Intersection ID: N/A	Main Street: I-485_RA	Cross Street: W_W_T_HARRIS_BV	Location:	E
ADA ID: E5D8B195DAA4	Ramp Type: Perp	Initial Pass/Fail: Pass	Overall Compliance: No	Severity Score: 15.25

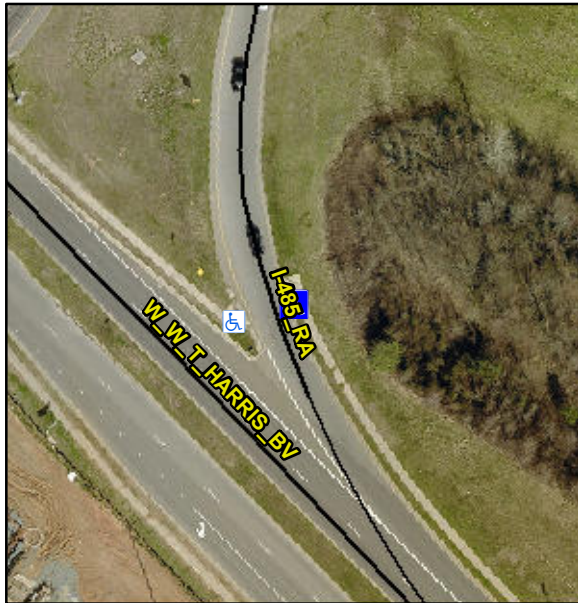
**Not Found, R304.5.3, R304.2.1,
R304.2.2-Perp, R304.3.2-Para,
R305.2, R304.5.4**

Compliance	Description	Data	Compliance	Description	Data
N/A	Ramp Length (in)	101.0	Yes	Ramp Slope (%)	6.6
Yes	Ramp Width (in)	48.0	No	Ramp XSlope (%)	4.8
N/A	Flare Type LT	Sloped	N/A	Flare Type RT	N/A
N/A	Flare Slope LT (%)	2.3	N/A	Flare Slope RT (%)	10.9
N/A	Flare Traversable LT?	No	N/A	Flare Traversable RT?	No
No	Landing Length (in)	N/A	Yes	DWS Provided?	Yes
No	Landing Width (in)	N/A	Yes	DWS Contrast?	Yes
No	Landing Slope (%)	N/A	Yes	DWS Length (in)	24.0
No	Landing X Slope (%)	N/A	Yes	DWS Full Width?	Yes
N/A	Landing Curb? (Y/N)	No	No	DWS Offset (in)	3.5
N/A	Shared Landing?	No			
Yes	Gutter Ponding?	No	No	Gutter Slope (%)	10.5
Yes	Gutter Lip Ht (in)	0.0	No	Gutter X Slope (%)	5.9
N/A	Painted X Walk1?	No	N/A	Painted X Walk2?	N/A
	X Walk 1 Direction	To W		X Walk 2 Direction	N/A
N/A	X Walk 1 Width (in)	N/A	N/A	X Walk 2 Width (in)	N/A
	X Walk 1 Slope (%)	6.8		X Walk 2 Slope (%)	N/A
	X Walk 1 X Slope (%)	3.7		X Walk 2 X Slope (%)	N/A

**Remove & Replace Entire Ramp.
Remove & Replace Gutter.**
